S.S. "City of Dieppe" 26/4/34

Proposed modification to Fore End.

Modification of fore end

Report No. 104343

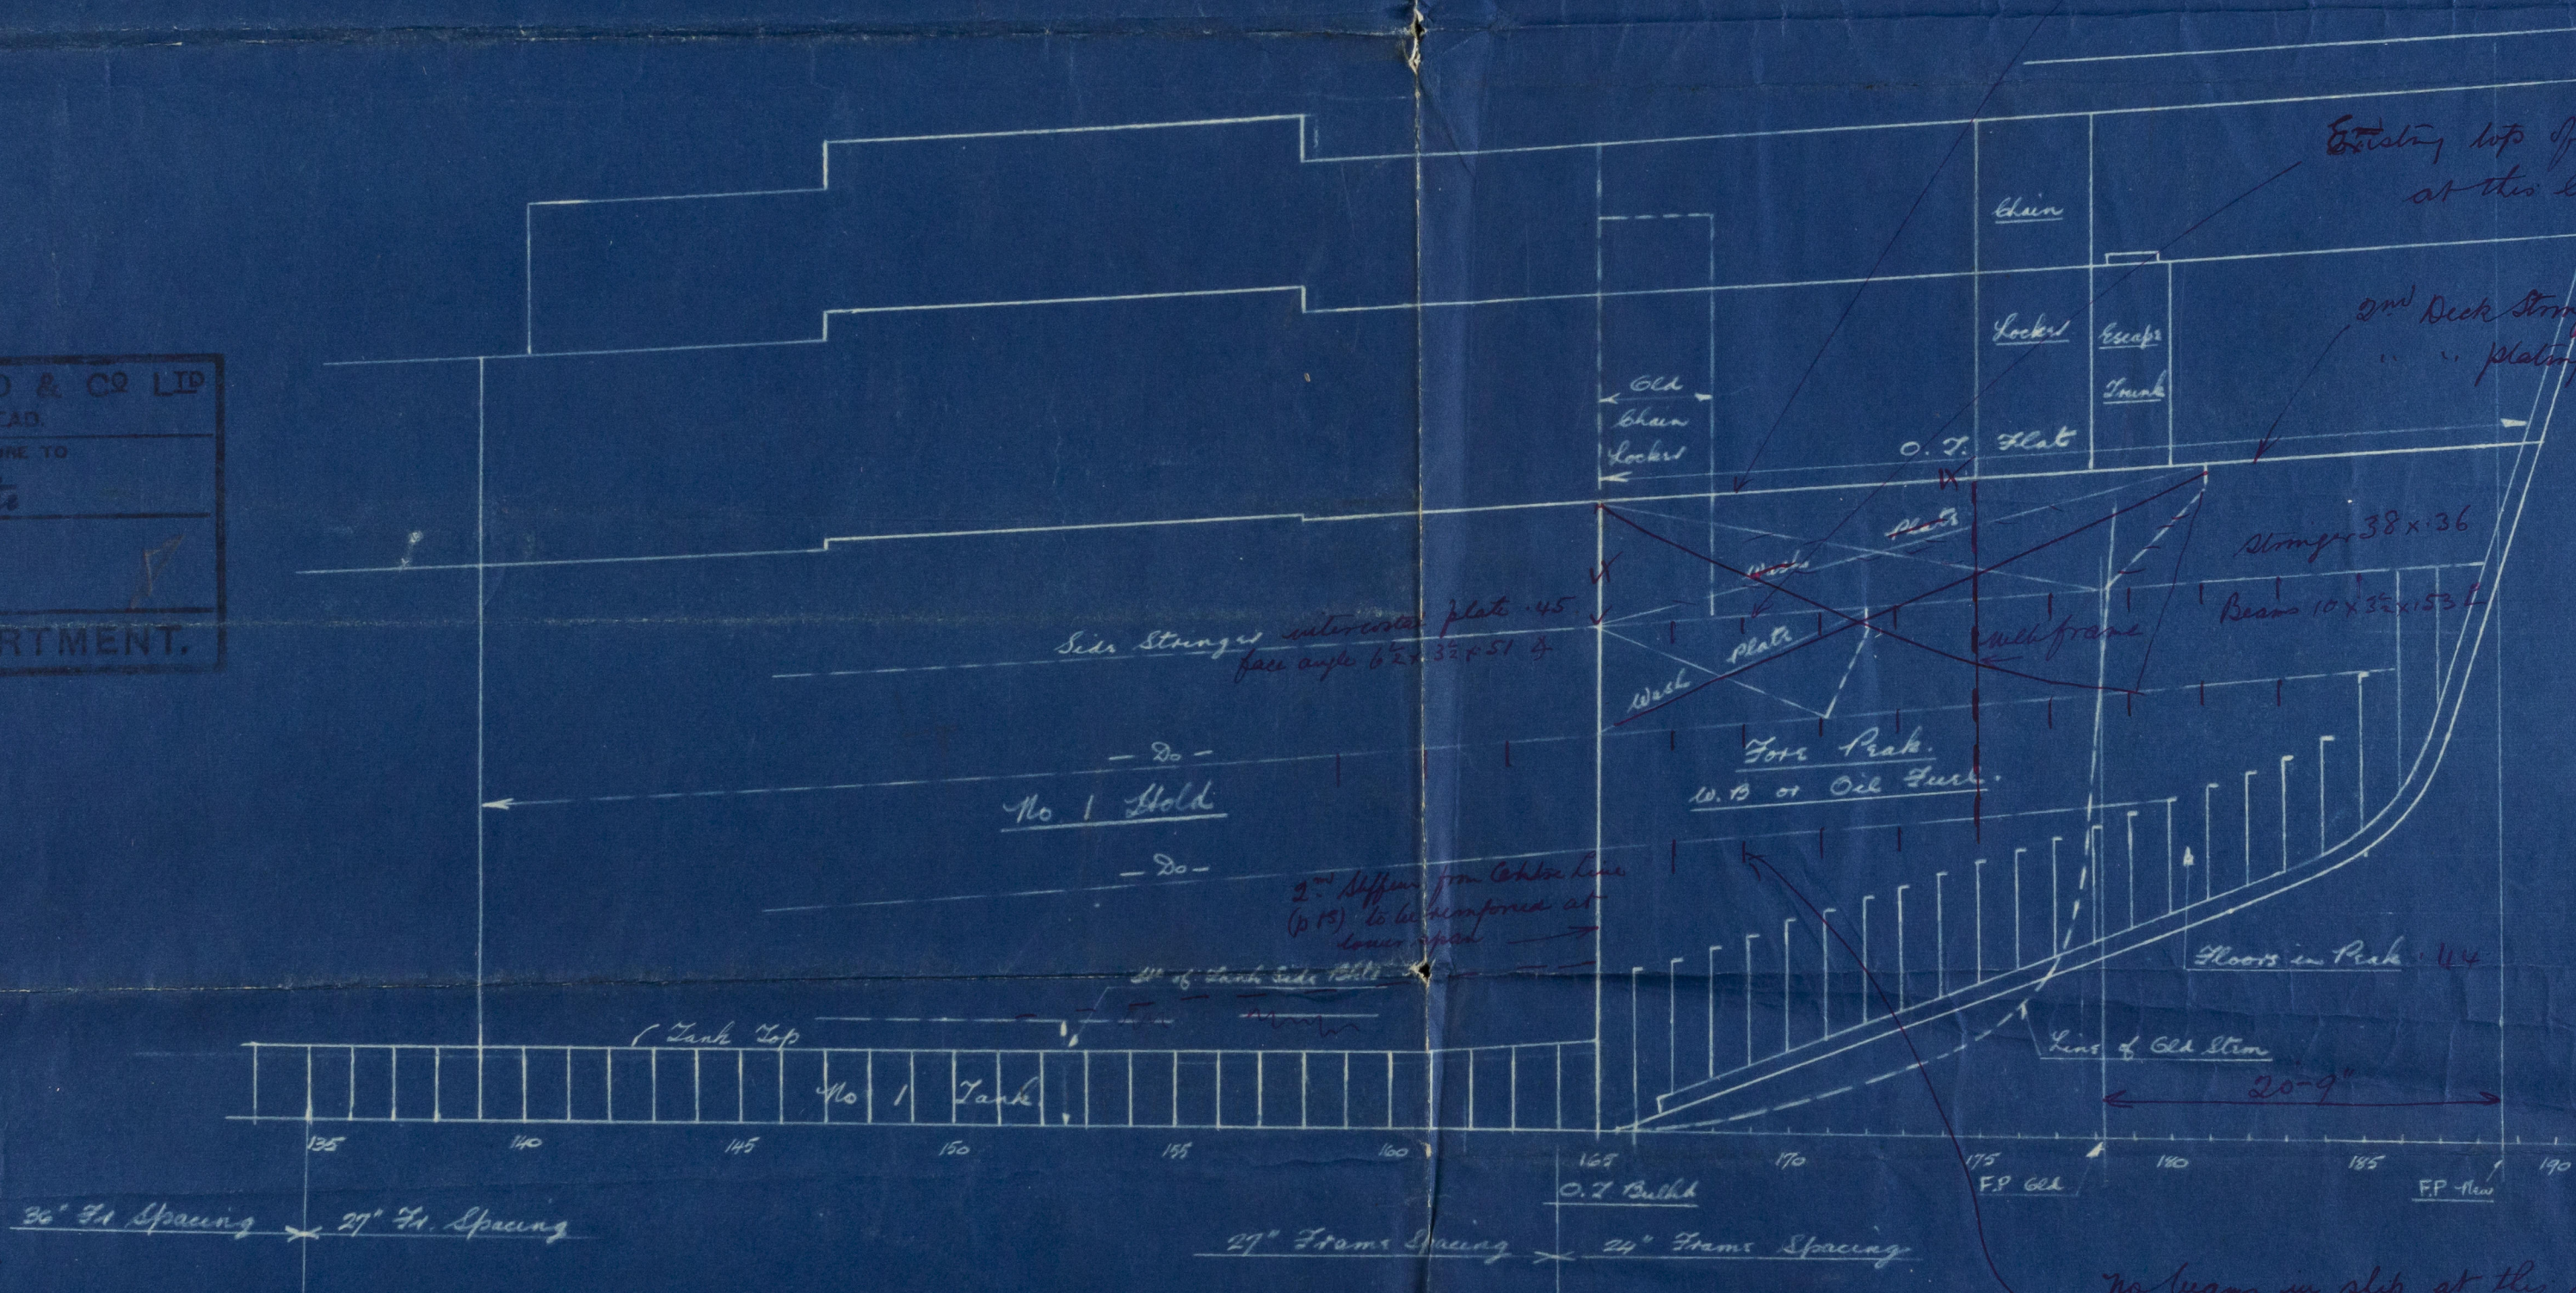
Before scantlings of beams can be considered plan will require to be submitted showing spans of beams & height of over flow.

Seams to be double riveted or existing seams reinforced by Electric Welding in way of oil.

No beams in slip at the stmper but there may be require to be fitted when exact form is determined.

Particulars of Web Strs (if any)
? Any modification to Equipment.
Particulars of Side Stringers.

Particulars of Panting Beams & Stringers in Peak.
Sigs of Stems 10 3/4 x 2 3/4
